SERVICE BULLETIN NZ SB142

Units affected: All TM12 units built in New Zealand as per the list attached.

MANDATORY MODIFICATION

Fig 4. Location of front bolts [to be changed].

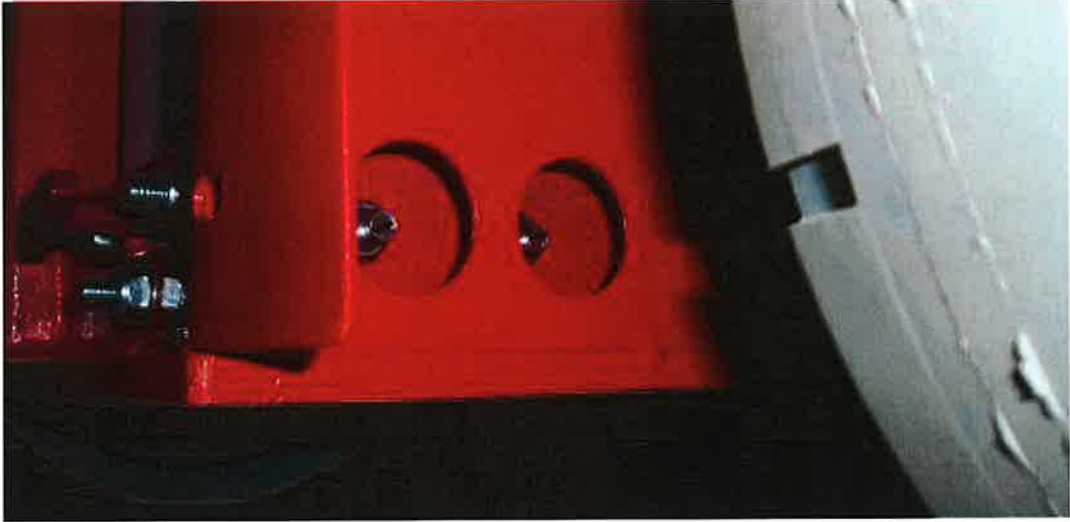
These machines have the incorrect grade of bolts fitted at the bottom of the mast assembly. These bolts must be replaced with a 10.9. grade not 8.8 which are currently fitted.

There are a total of 11 bolts at the bottom of the mast assembly however this procedure requires that only 9 of them are to be replaced.

Remove and replace the bolts one at a time, note that the new GR10.9 bolts must be done up to a torque setting of 69Nm [50lbft].

The new bolts are part # 3616-10030, the new nut is part # 13323-10. These items will be supplied by Snorkel free of charge.
